PLANNING AND DEVELOPMENT BOARD

Supplementary Report

PAP/2017/0660 – The Cuckoo’s Rest, Dordon and PAP/2017/0659 – New Street, Dordon

Structural Inspection Report
of The Cuckoos Rest Pub
Dordon

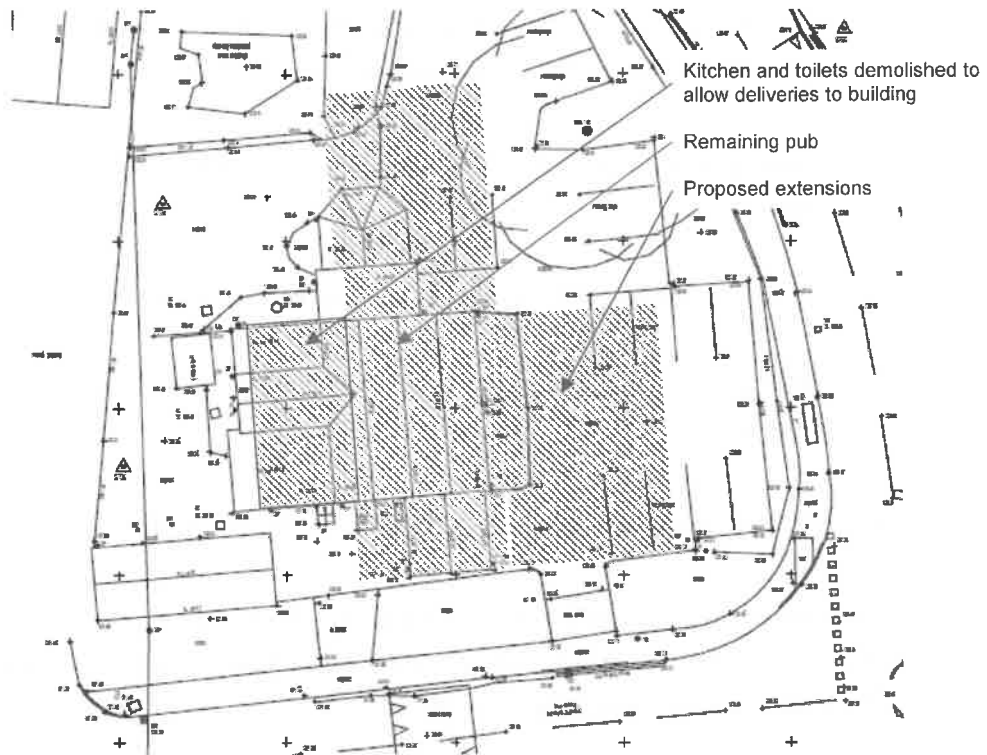
- 8.0 The floor area of the existing building once the toilets and kitchen (shown in blue) are removed is 126m². The shop floor of the new building is proposed be 426m² which excludes unit B. As such, the existing building would need to be considerably extended (shown in red) which would require an extension towards Whitehouse Road. This would cover part of the front elevation of the existing pub and drastically alter the aesthetics of the existing building.
